File FPP-1996-135

Name: Hill Court Subdivision – Sand Cliff Court – Lot 2, Blk 13, Ridges #4

FILE: FPP-96-135
DATE: June 26, 1996
STAFF: Bill Nebeker
REQUEST: Final Plat and Plan for Hill View Court Subdivision; 12 unit townhouse development
LOCATION: Northeast of Ridge View Drive; North side of Hill View Drive
APPLICANT: W.D. Garrison for GNT Development Corp.

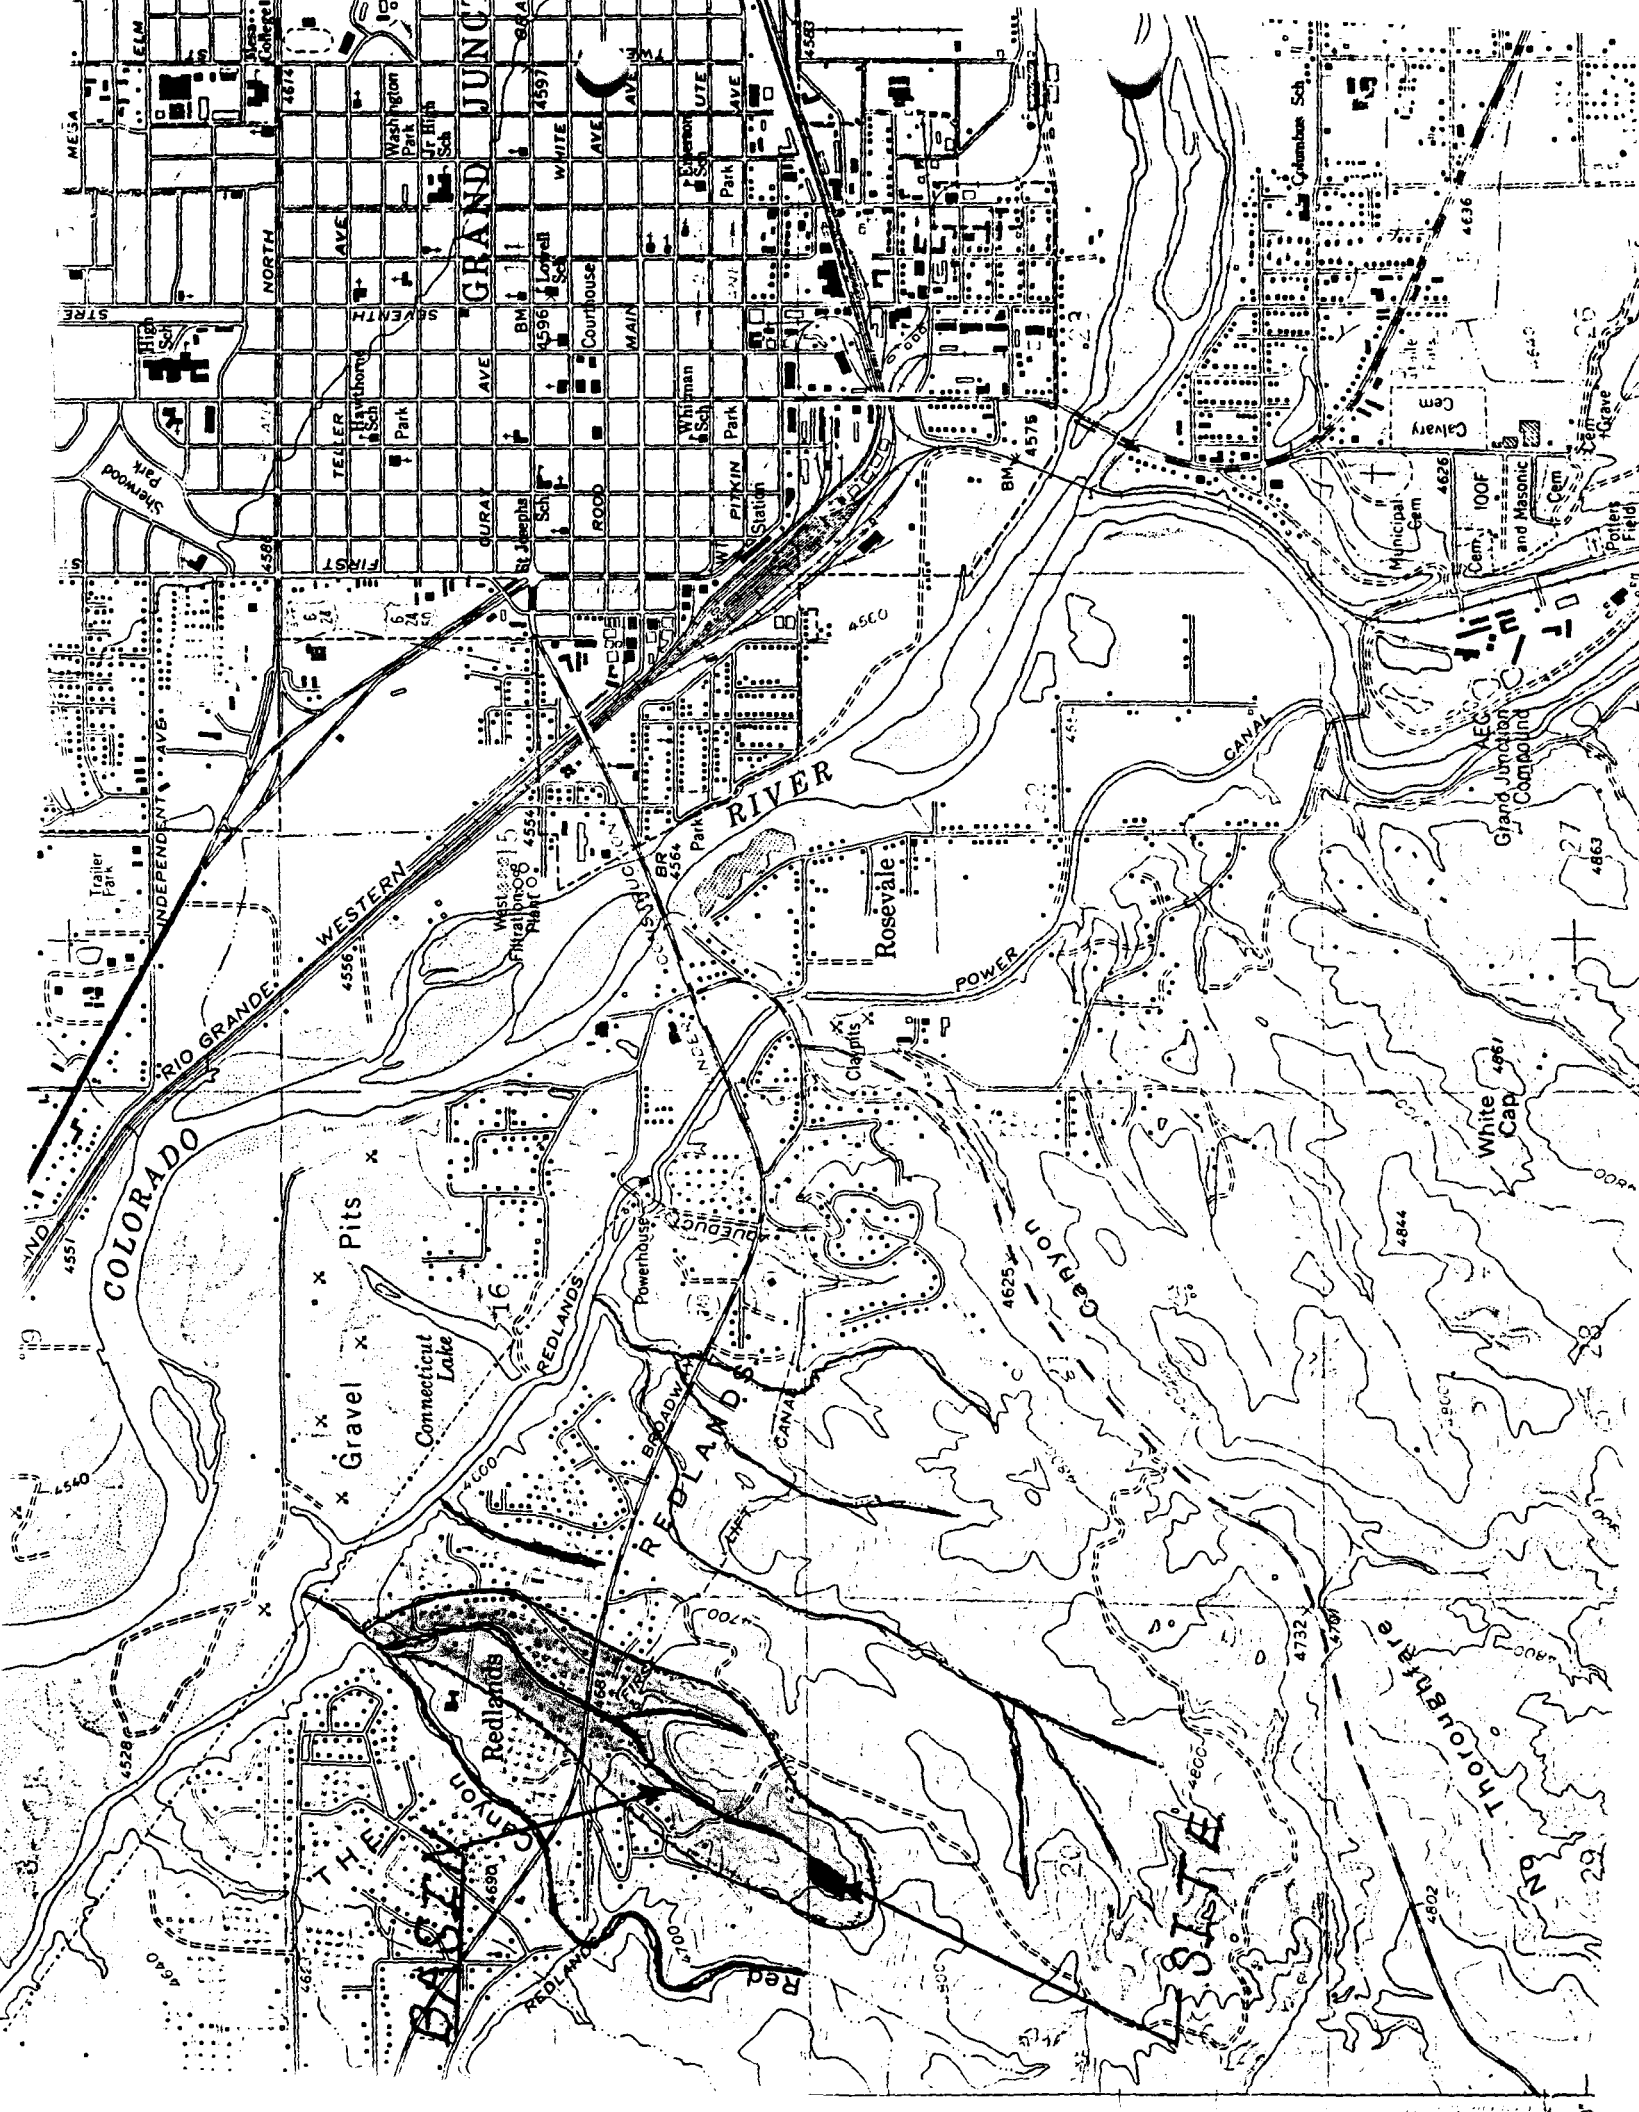
The attached sketch shows the walk and also how it would fit into the overall plan. The walk as shown will carry 14 CFS, while the 100 year Q is 9.3 CFS. The walk will carry the 100 year Q and still leave 1.3 feet that is not used to carry water. This would be a very good double use as it is difficult to imagine anyone using the walkway during a 2 year storm let alone the 100 year storm.

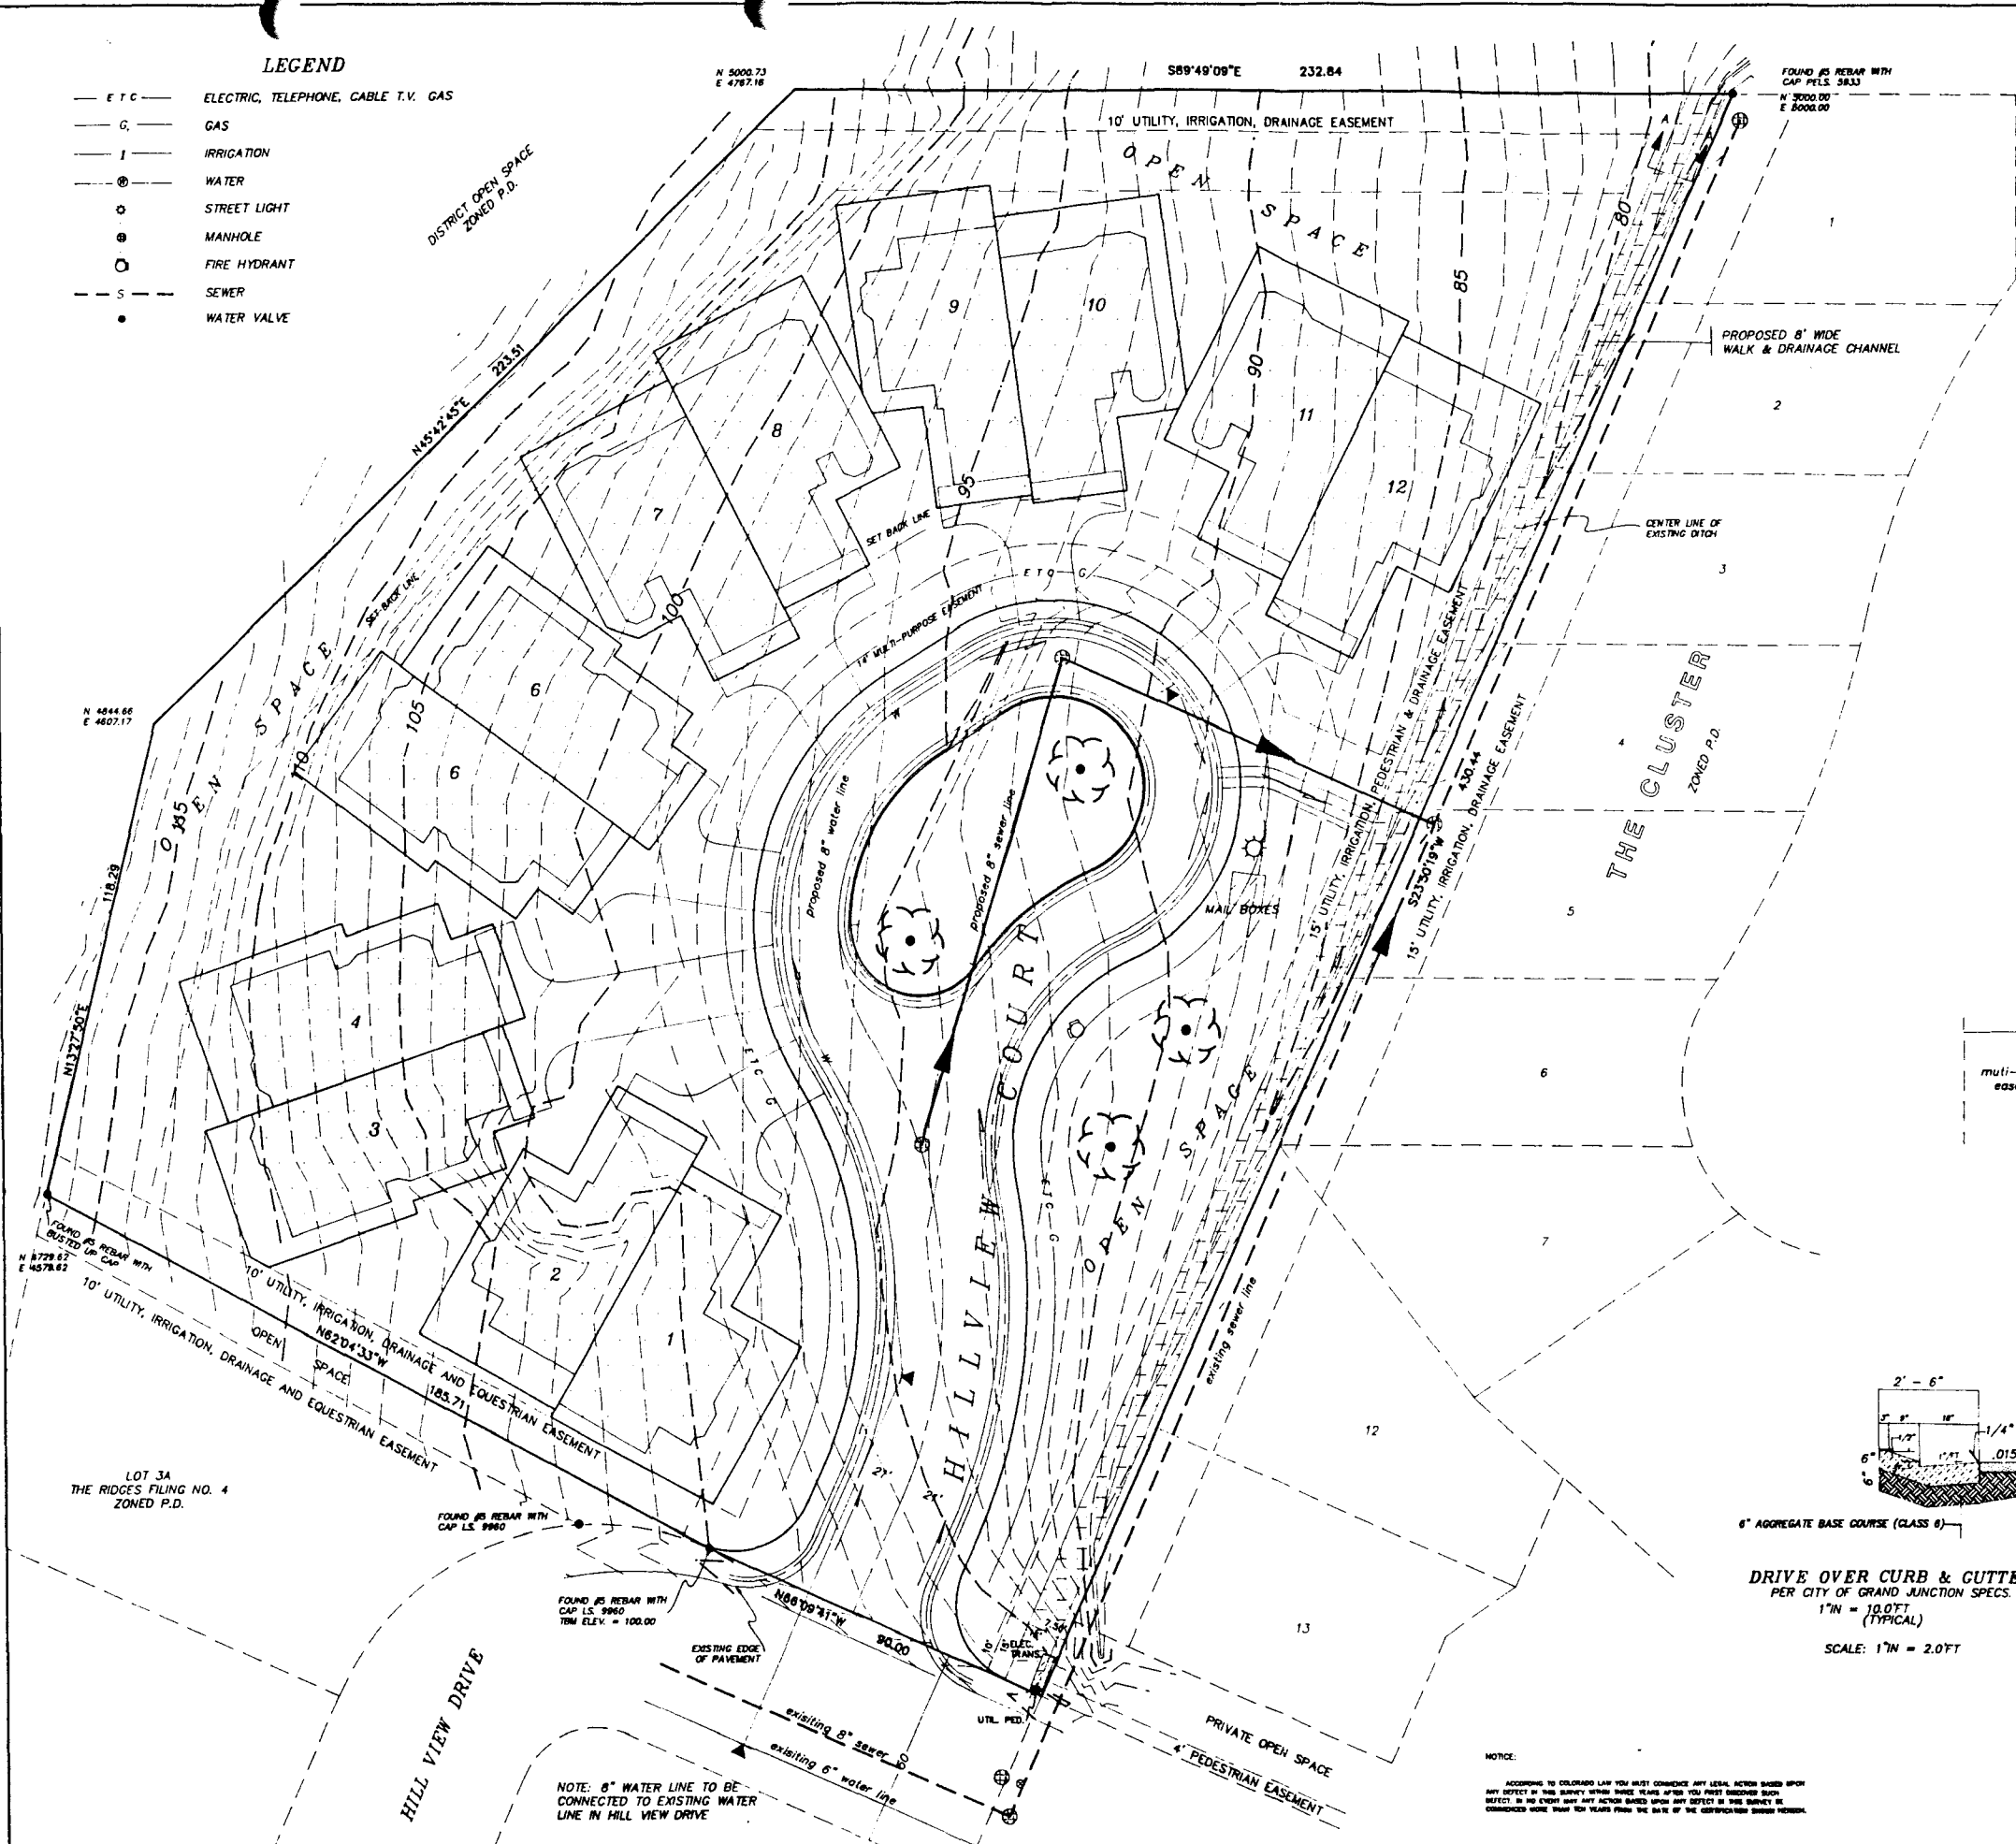
The proposed hydrant must be moved south along Hill View Court about 100'. A revised utility composite reflecting this change must be submitted to the fire department.

If driveways are installed as shown on enclosed "Composite Plan", 14' multi-purpose front lot easements should be sufficient for installation of gas and electric facilities to these lots. If driveways are altered, we request that all "Open Space" also be designated as utility easement, per review of this subdivision on File #PP-96-51, dated 3/6/96.
